Access Compliance Report

Public Rights-of-Way

(Curb Ramps)

Intersection ID: 12684	Main Street: S_BREVARD_ST	Cross Street: E_4TH_ST	Location: W
ADA ID: E14A5FCD91D1	Ramp Type: Perp	Initial Pass/Fail: Fail	Overall Compliance: No
			Severity Score: 47.5
Codes/Mitigation Info/Possible Solution		Field Measurements/Component Compliance

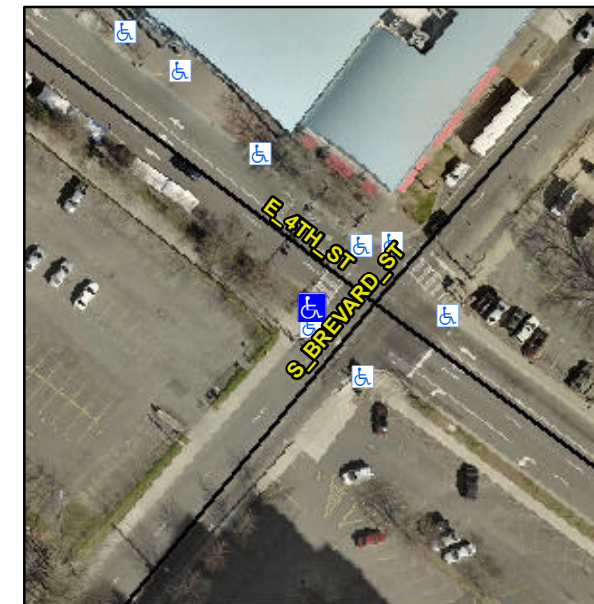
Not Found, R304.5.1, R304.2.2

Compliance	Description	Data	Compliance	Description	Data
N/A	Ramp Length (in)	90.0	No	Ramp Slope (%)	8.8
No	Ramp Width (in)	30.0	Yes	Ramp XSlope (%)	0.5
N/A	Flare Type LT	N/A	N/A	Flare Type RT	N/A
N/A	Flare Slope LT (%)	N/A	N/A	Flare Slope RT (%)	N/A
N/A	Flare Traversable LT?	N/A	N/A	Flare Traversable RT?	N/A
N/A	Landing Length (in)	N/A	N/A	DWS Provided?	N/A
N/A	Landing Width (in)	N/A	N/A	DWS Contrast?	N/A
N/A	Landing Slope (%)	N/A	N/A	DWS Length (in)	N/A
N/A	Landing X Slope (%)	N/A	N/A	DWS Full Width?	N/A
N/A	Landing Curb? (Y/N)	N/A	N/A	DWS Offset (in)	N/A
N/A	Shared Landing?	N/A			
N/A	Gutter Ponding?	N/A	N/A	Gutter Slope (%)	N/A
N/A	Gutter Lip Ht (in)	N/A	N/A	Gutter X Slope (%)	N/A
N/A	Painted X Walk1?	Yes	N/A	Painted X Walk2?	N/A
	X Walk 1 Direction	To NE		X Walk 2 Direction	N/A
N/A	X Walk 1 Width (in)	111.0	N/A	X Walk 2 Width (in)	N/A
	X Walk 1 Slope (%)	1.2		X Walk 2 Slope (%)	N/A
	X Walk 1 X Slope (%)	0.5		X Walk 2 X Slope (%)	N/A

Remove & Replace Entire Ramp.
